Product/Process Change Notice (PCN)

PCN_WS-HP_Cover_Change_20130806

Product Affected: WS-HP

PN : 416 131 160 808/810/812

416 131 160 8xx

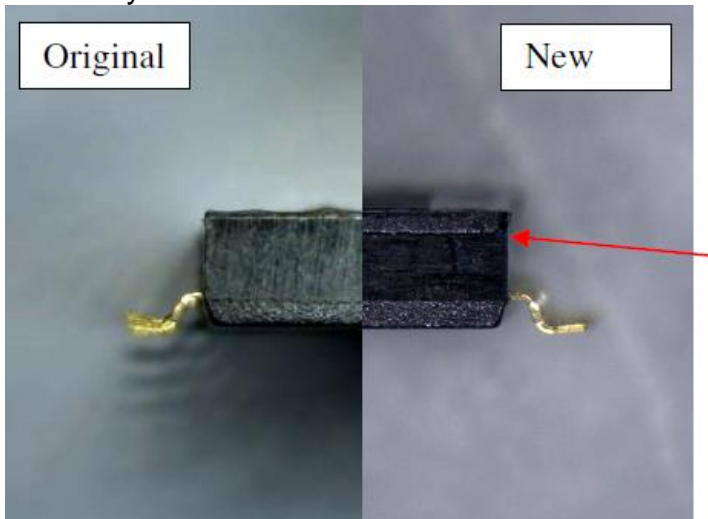
1. Purpose of change :
Due to massive production, injection tooling/moulding were broken.
2. Actions :
Tooling/moulding was re-built. There is no change of dimension or specification implemented and function are not affected. For more details change, please see below photos.
3. Revise Specification
No specification required to be changed.
4. Cause this is a continuously improvement, therefore, the old version of the product is still available. Both versions can be sent out to customer until the old version is complete sold out. New product is available from : Lot number 254020071329000.
